**CITY OF MANNINGTON  
MARION COUNTY, WEST VIRGINIA  
CITY OF MANNINGTON MUNICIPAL POOL**

**ADDENDUM #2**

**JUNE 20, 2023**

**THRASHER PROJECT #010-10191**

SHEET No.  
**C1.00**

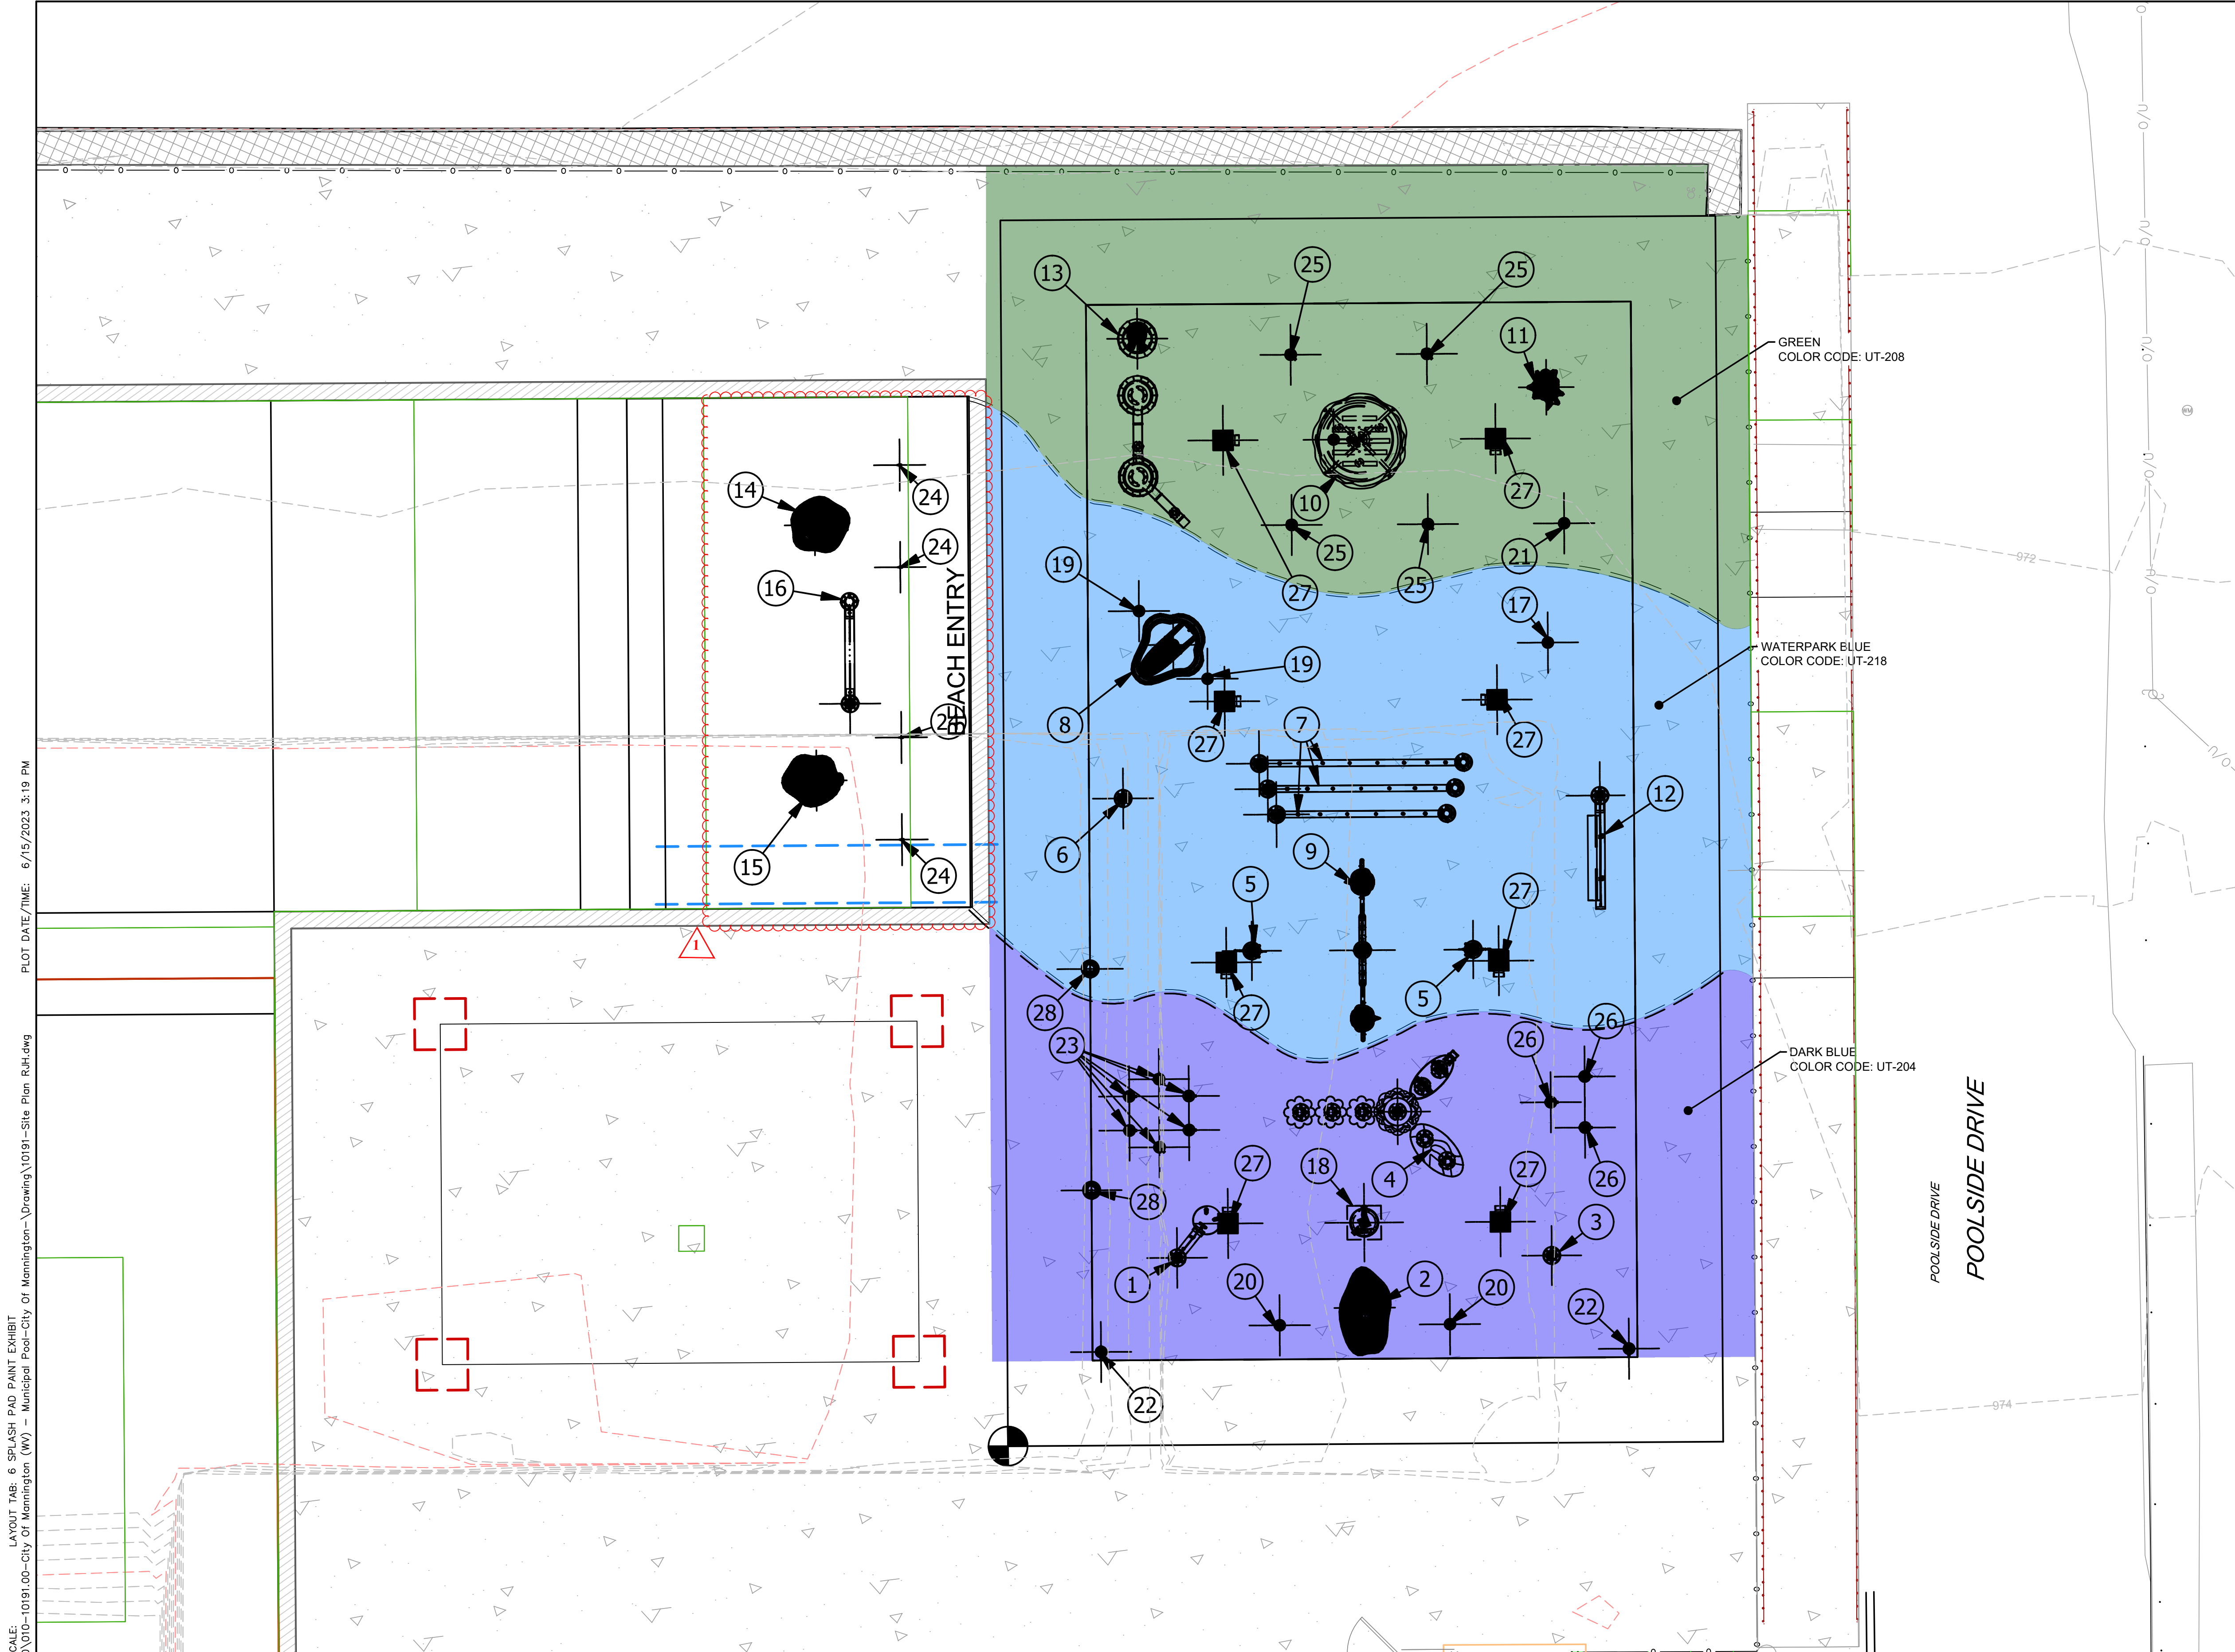
1. Sheet C1.00 was revised to reflect the reduction in area for Item 19.0 "Tuff Coat Surface Paint"
2. Sheet C3.05 was revised to remove the Tuff Coat Surface from the beach entry of the pool. This area will be covered with the pool liner and does not require the Tuff Coat Surface.
3. Sheet C7.01 was revised to clarify which items are to be provided and installed by the Contractor.
4. Sheet A1.02 has been revised to remove the roofing and gutter work from the scope.
5. Sheet A2.01 has been revised to remove gutter and siding work from the scope.
6. Sheet A3.01 has been revised to remove gutter, fascia, and soffit work from the scope.
7. Sheet A7.01 has been revised to show the revised finish schedules.

REV#	MRL	DATE	DESCRIPTION
REV1	MRL	06.15.2023	REVISED QUANTITY OF TUFF COAT SURFACE
NO.	BY	DATE	DESCRIPTION

SHEET No.  
**C7.01**

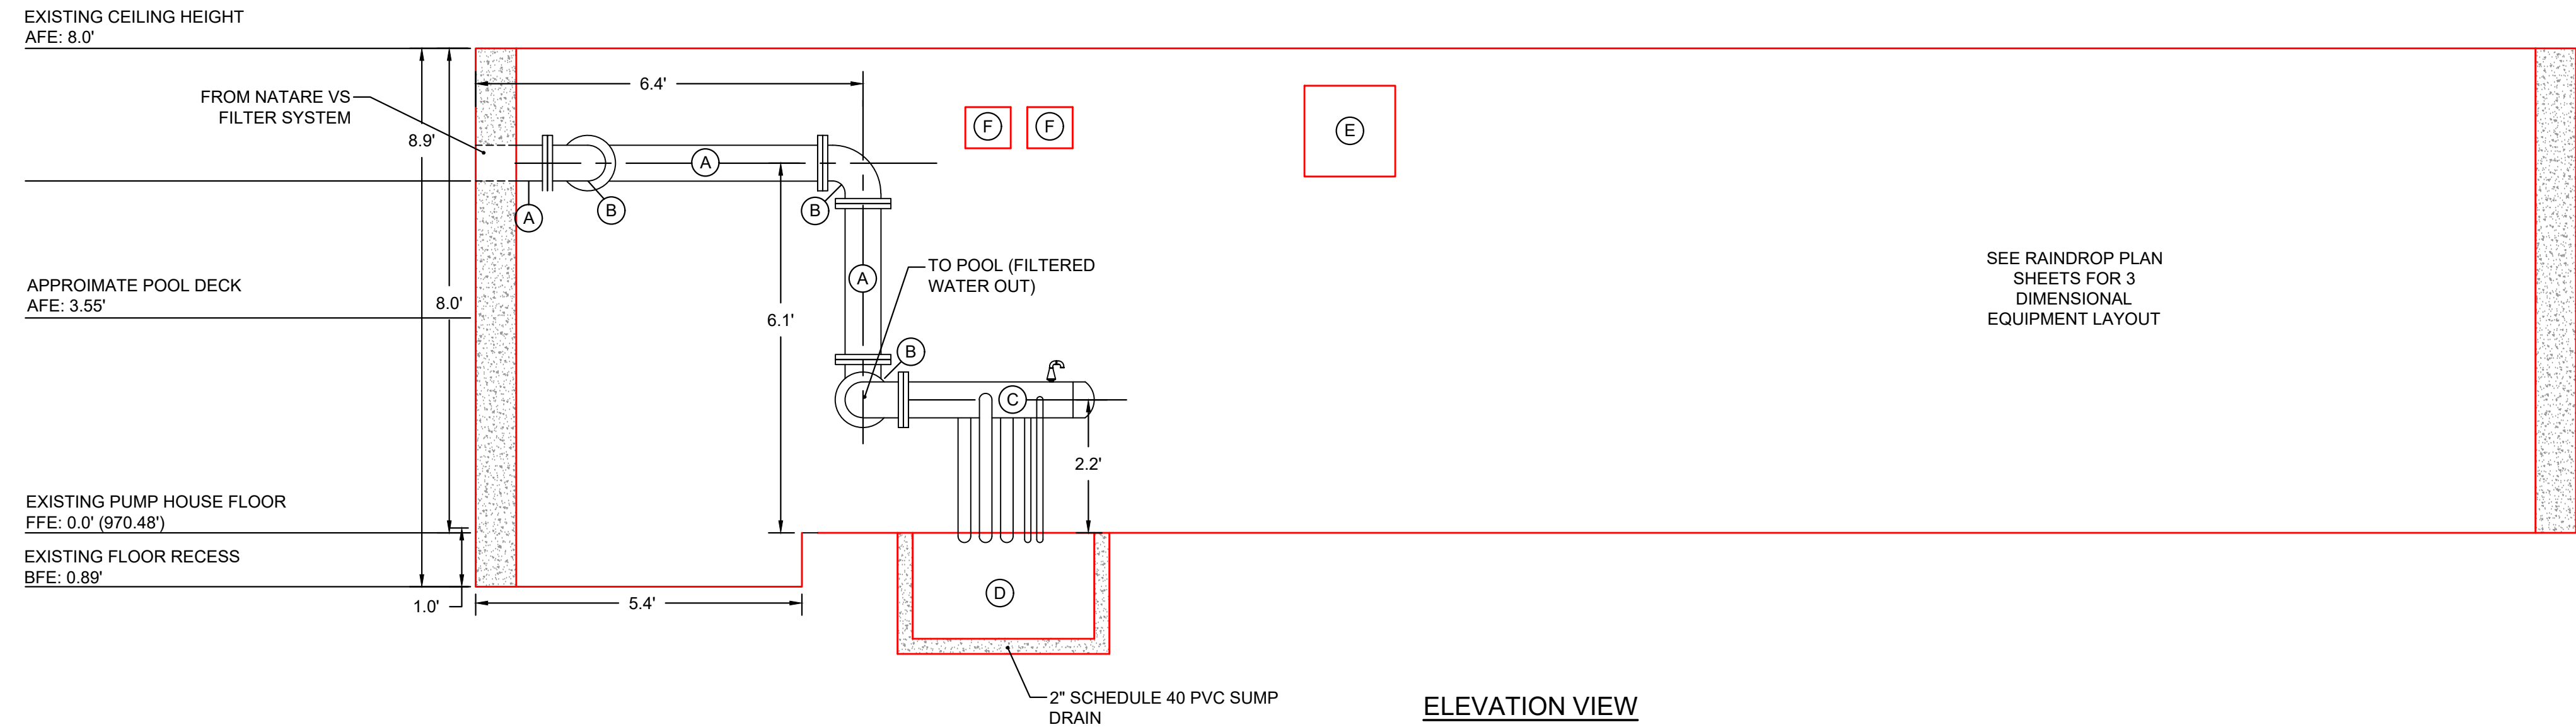
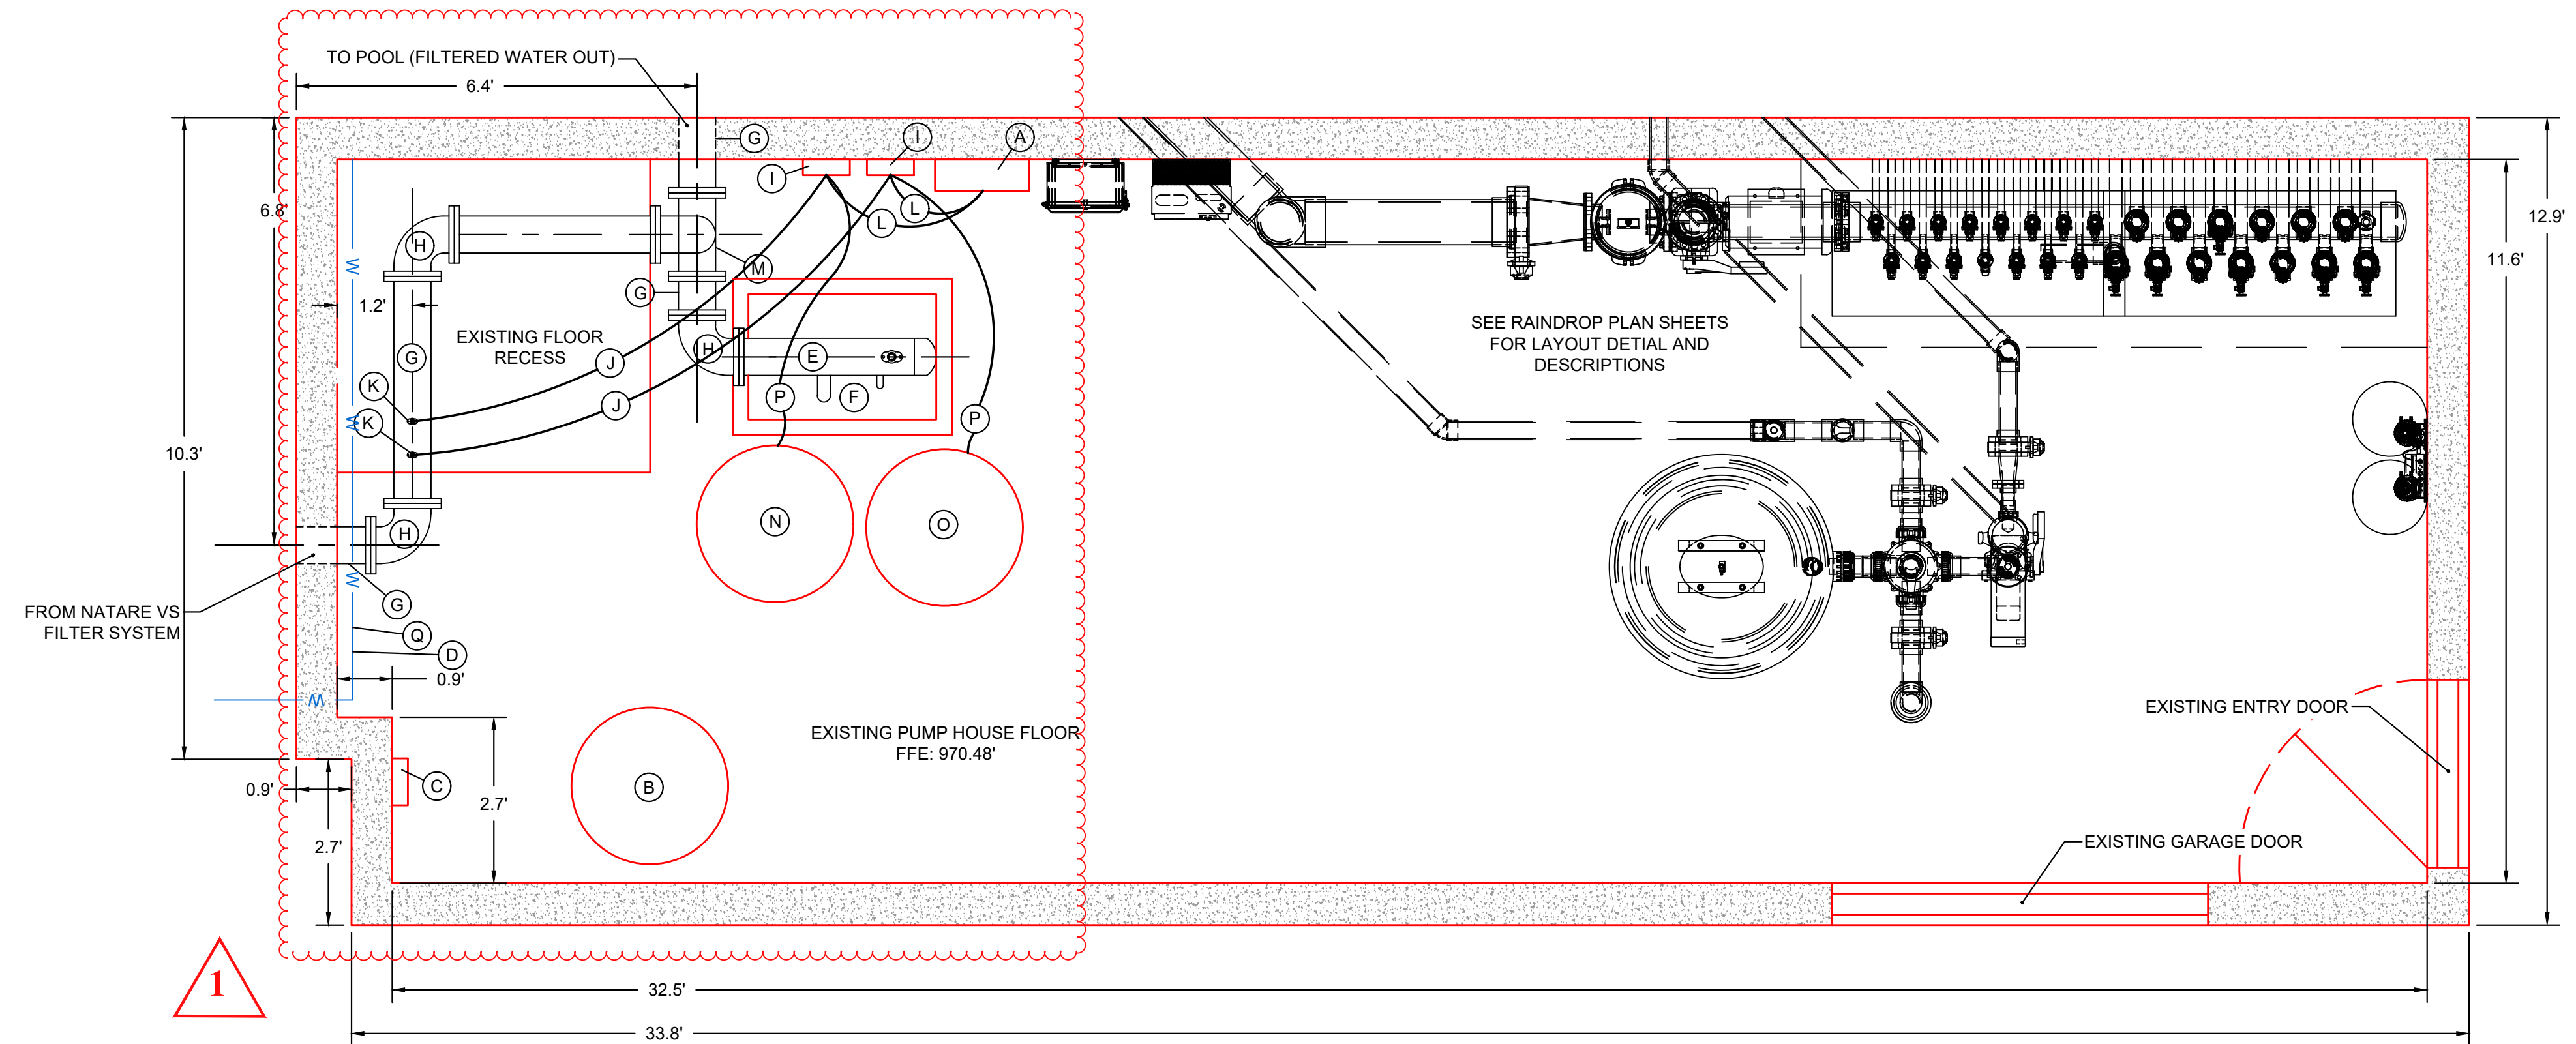
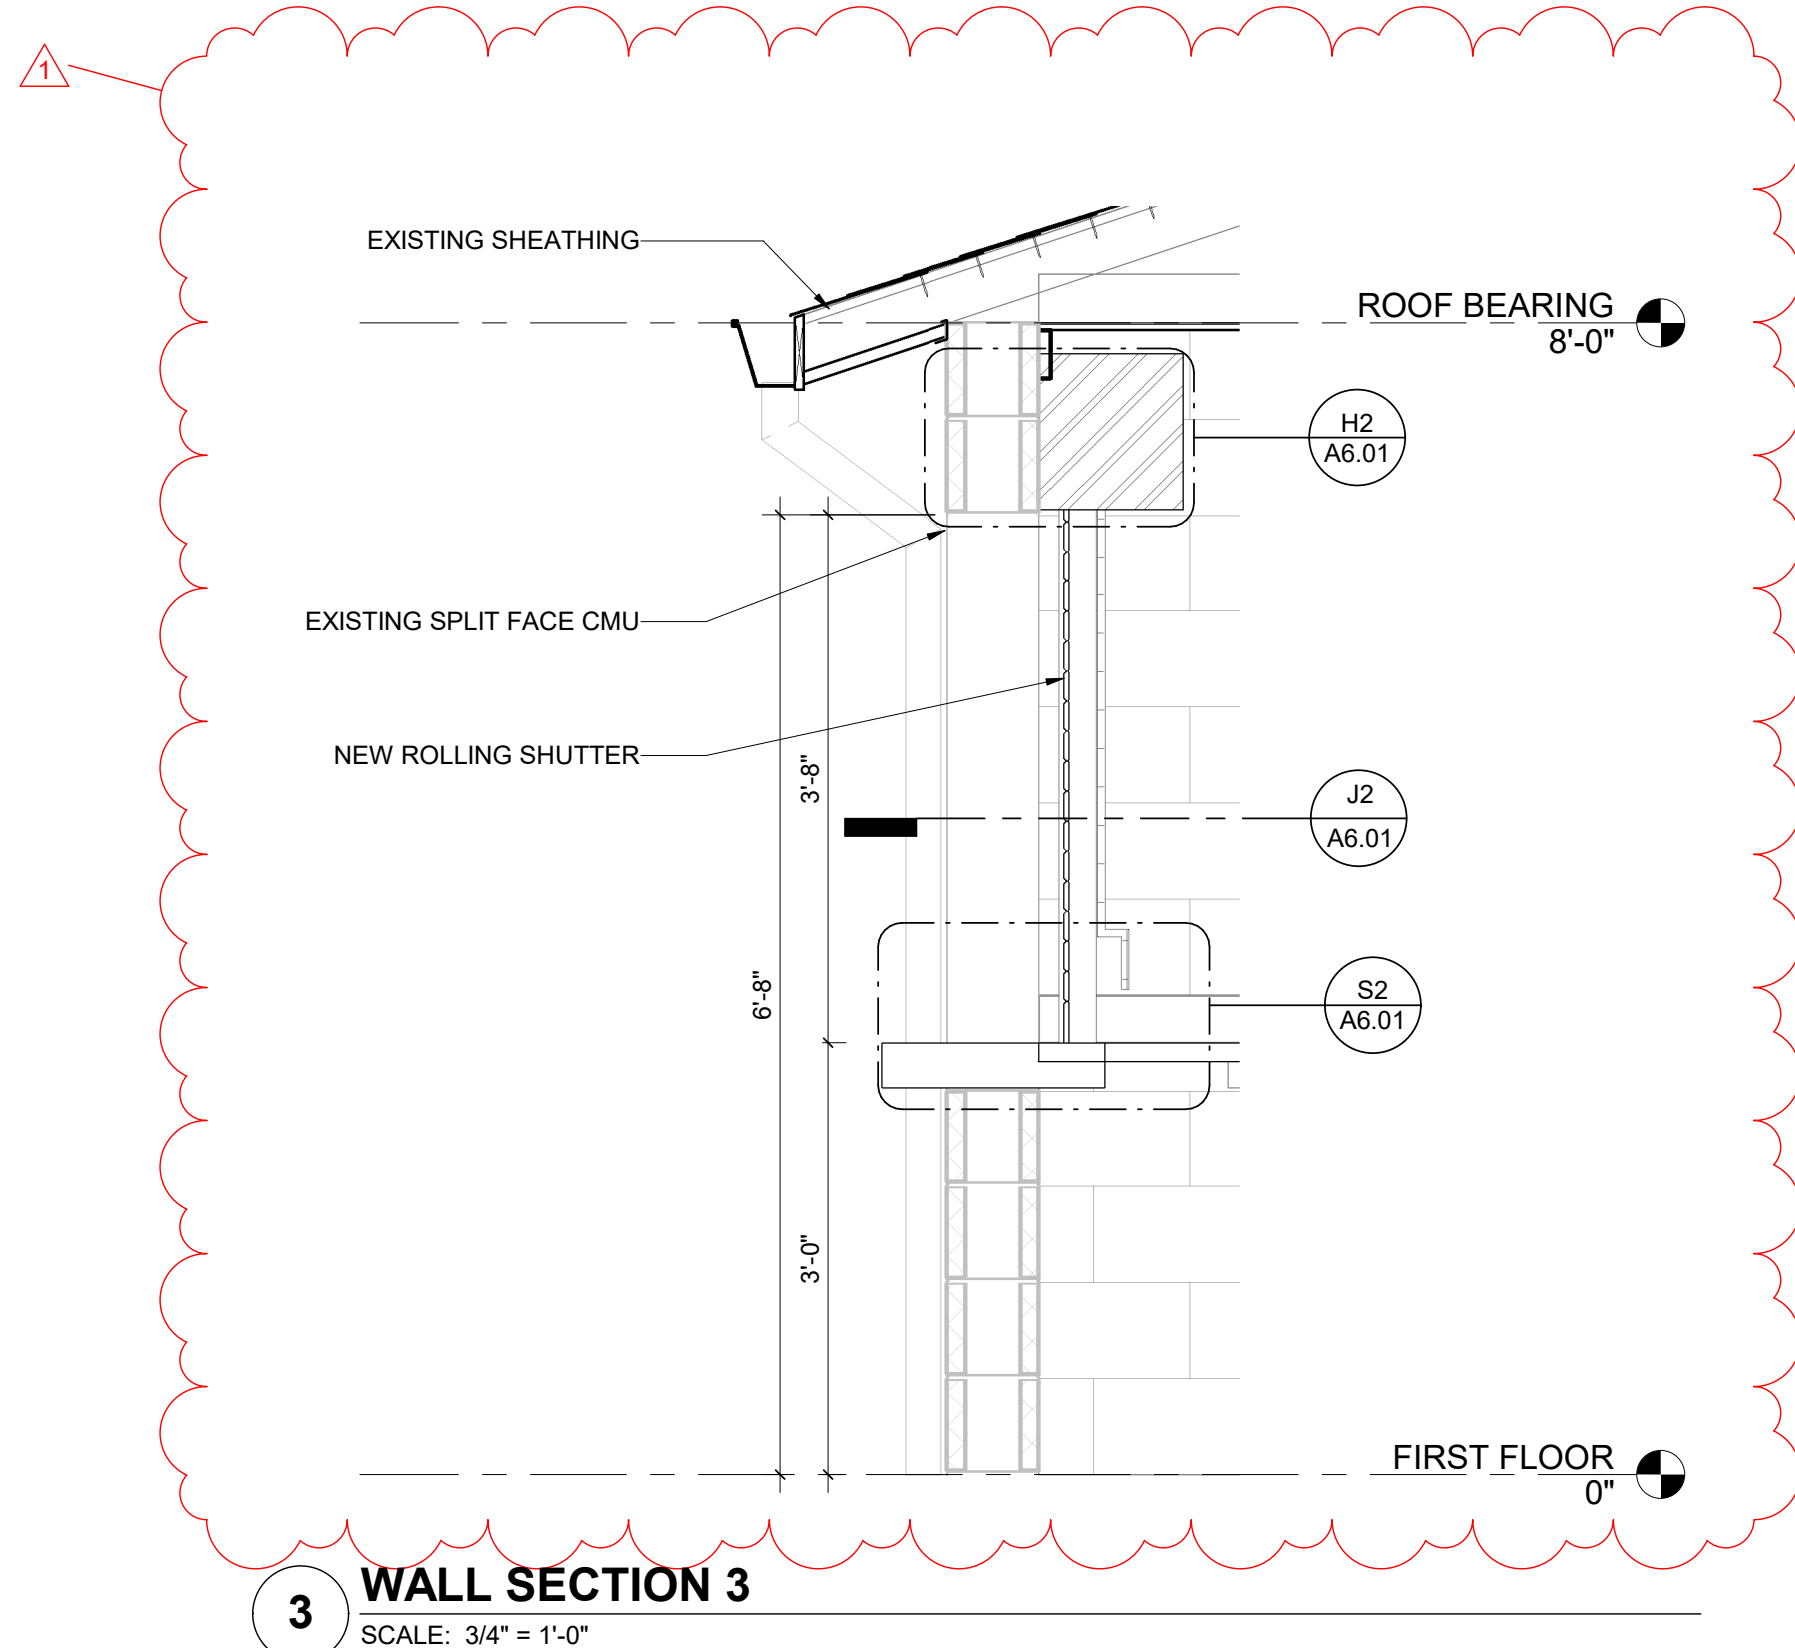
Does the contractor need to buy any pool equipment? pumps, chlorinator, ph balancer, etc.?

*The Contractor will be responsible for purchasing and installing any items that are not listed as "Provided and/or Installed by Others". See sheet C7.01.*

NO.	REV	BY	DATE	RESPONSIBILITY OF POOL EQUIPMENT PURCHASE AND INSTALLATION	DESCRIPTION
	REV1	RJH	06.20.2023
